INDESIT company

Model type:
TAN2S

Commercial code:
F034169

51421m0 Exploded views

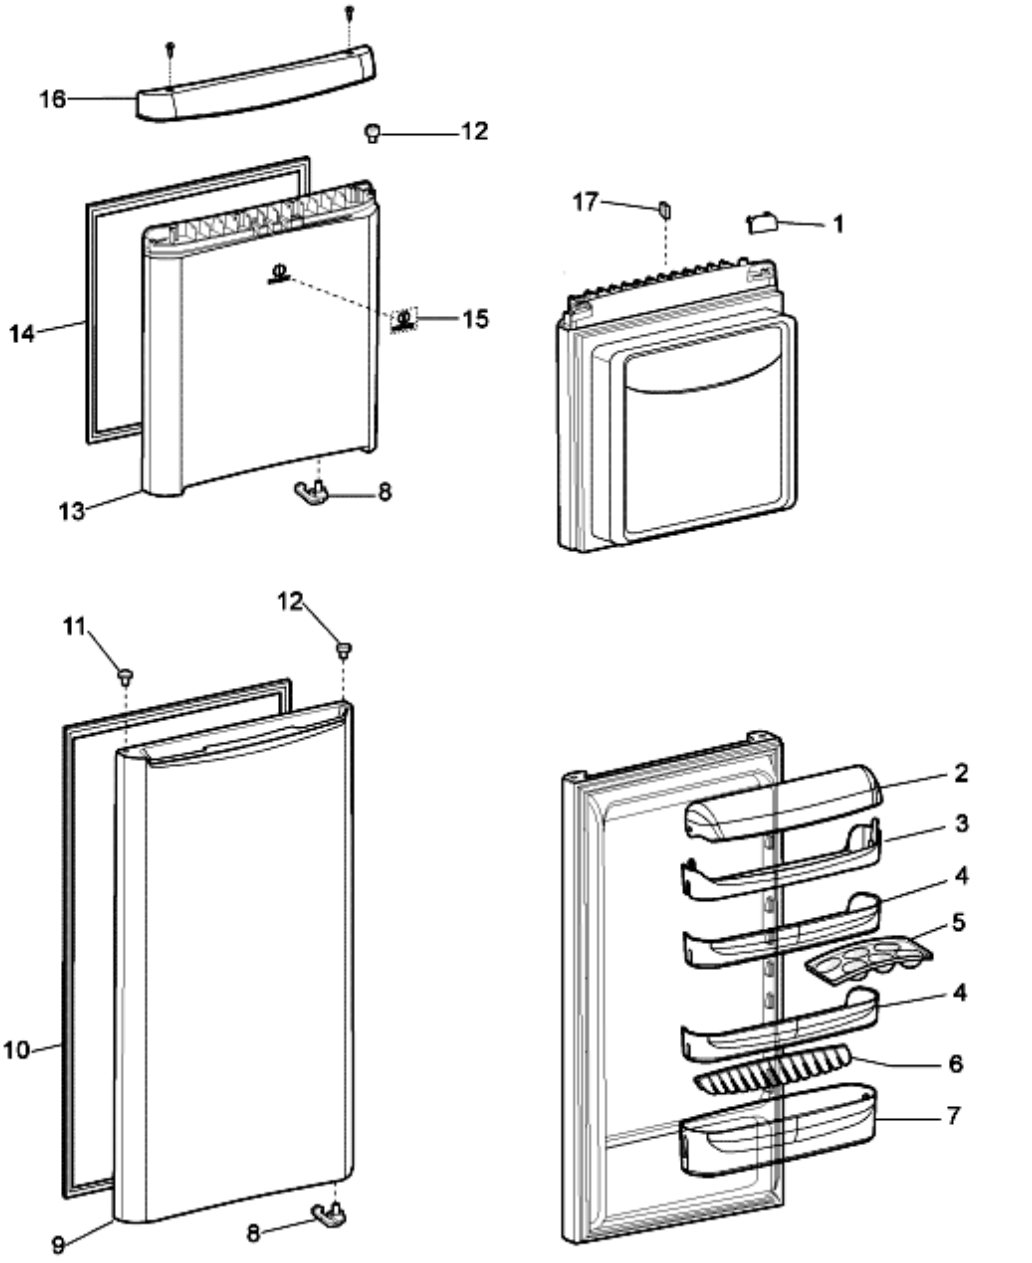
n2507b01: Color change on inner door upper heading

From s/n 70129.0001 (January 2007) on teak – inox – silver Indesit models has been introduction in production a new white inner door upper heading / white hinge blanking plate.

The spare part code of the door remain the same.

When replacing the door in the products produced before the modification replacing also the brown hinge blanking plate (for teak versions), grey (for silver version), aluminium (for inox versions) with the white.

n2511b02: ELIMINATION COVER FOR UPPER DOOR SHELF-INTERNAL ACCESSORIES RESTYLING

Cover for upper door shelf has been eliminated. The upper door shelf has been standardized with the middle one. Subsequently has been standardized with transparent internal accessories instead of those in light blue colour once stock has depleted.

5142260 Exploded views

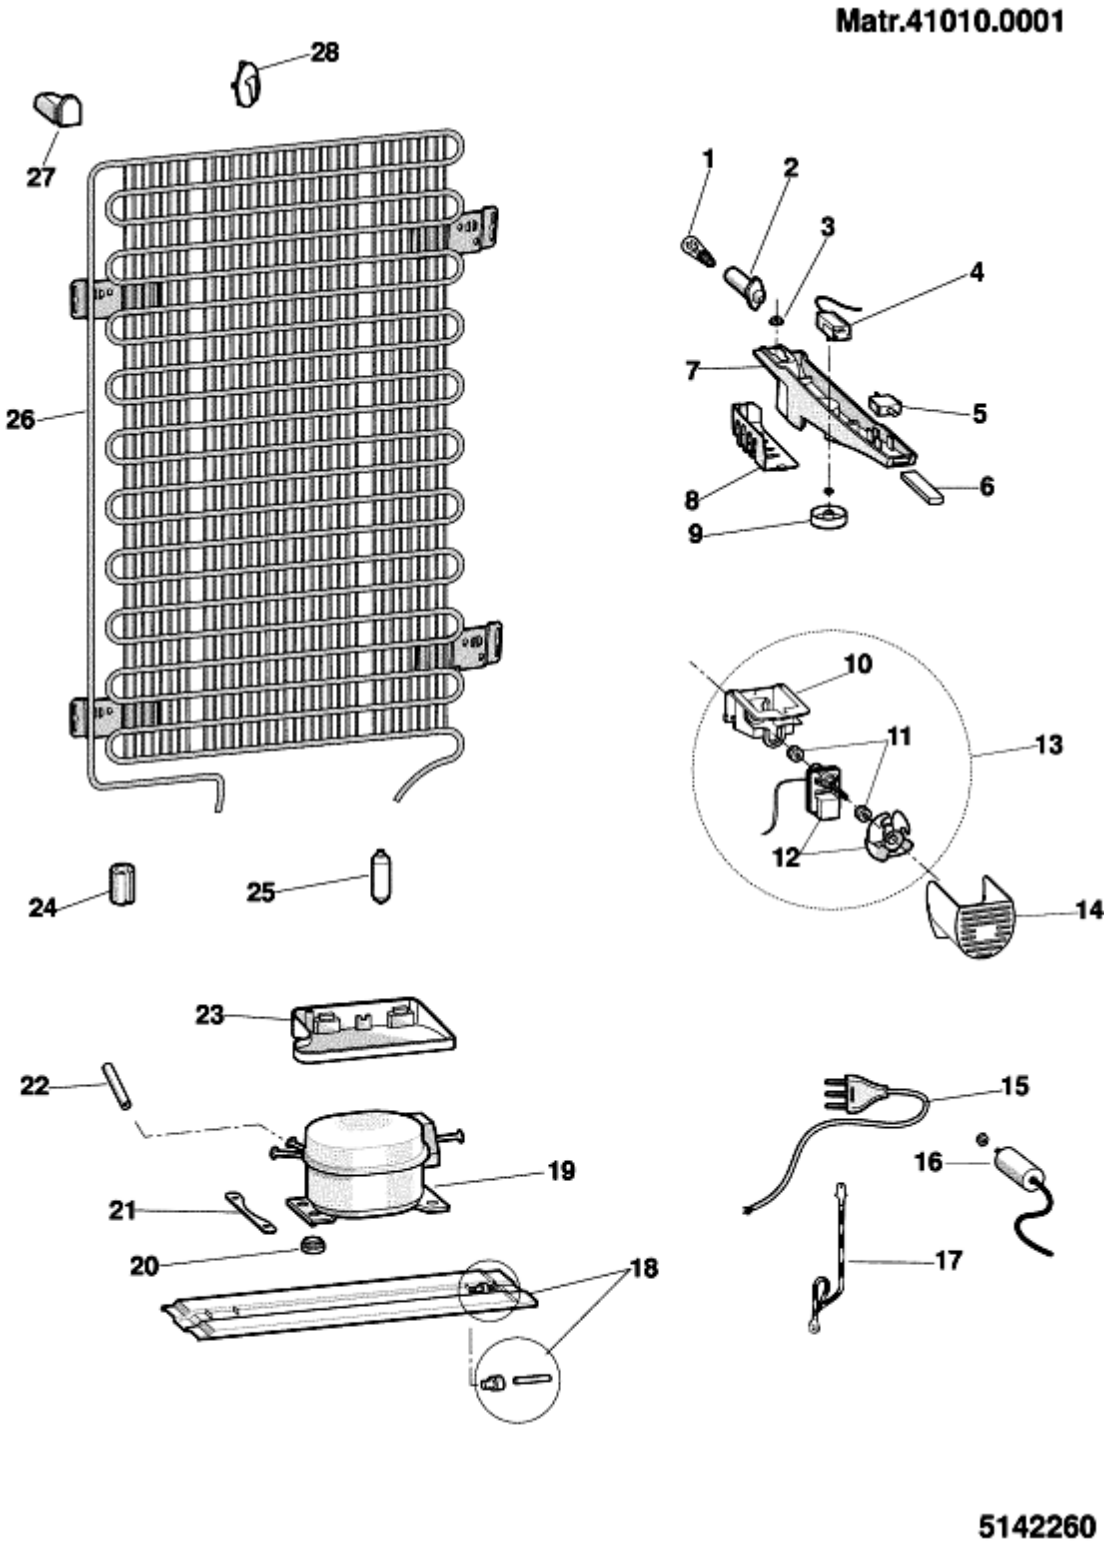
n1025101: Disappearing bulb thermostats (warning!)

The apparatus that provide for the thermostat to be threaded into a small tube located inside the fridge cabinet are noted as versions with "disappearing bulbs".
The bulb must be inserted for a length equal to the position indicated on the colored ribbon (small mark) which confirms the correct position of the bulb in the evaporation area, otherwise causing the poor performance of the apparatus.
Therefore in cases of thermostat replacement it will be necessary to reset on the new, if missing, the same small mark position and always check that the thermostat bulb is completely devoid of the sheath so as to ease its insertion.
The entrance of the small tube, placed in the thermostat container, is protected by a perforation cover in order to avoid the formation of condensation. The perforation cover was initially situated externally and could be substituted with putty or silicone.
For the models with disappearing bulb thermostats, the spare parts are inclusive of the small colored marker,

however check that its position corresponds to that on the thermostat that will be replaced.
The spare part description always notes the position of the small marker in millimeters as well as the thermostat initials.

n1025135: Thermostat box on Indesit/Ariston Opera-60 refrigerators (low A.T. +16°C)

As of July 2003, two new "Low ambient temperature thermostat box kits" have been introduced as spare parts for Ariston Opera-60 and Indesit 2000 - 2002 - 2003 range refrigerators with Giugiaro thermostat box (075646).

The two kits have a different thermostat (remember to always check the position of the mark).

The kit must only be used to solve freezer performance problems caused by an ambient temperature below +16° C.
This innovative kit features a DIODE, activated by means of the luminous switch, which makes the thermostat box lamp turn on. It must be activated when the ambient temperature falls below +13°C (closed contacts: see the wiring diagram that comes with the kit).
The heat produced by the lamp activates the thermostat, thus ensuring regular operation of the appliance.
When replacing the thermostat box, no component can be reused (including the wiring).
The kit wiring has pin terminals for connection to the terminal block on the compressor; some modifications may be required for other solutions.
Given below is the list of kit items available as spare parts:
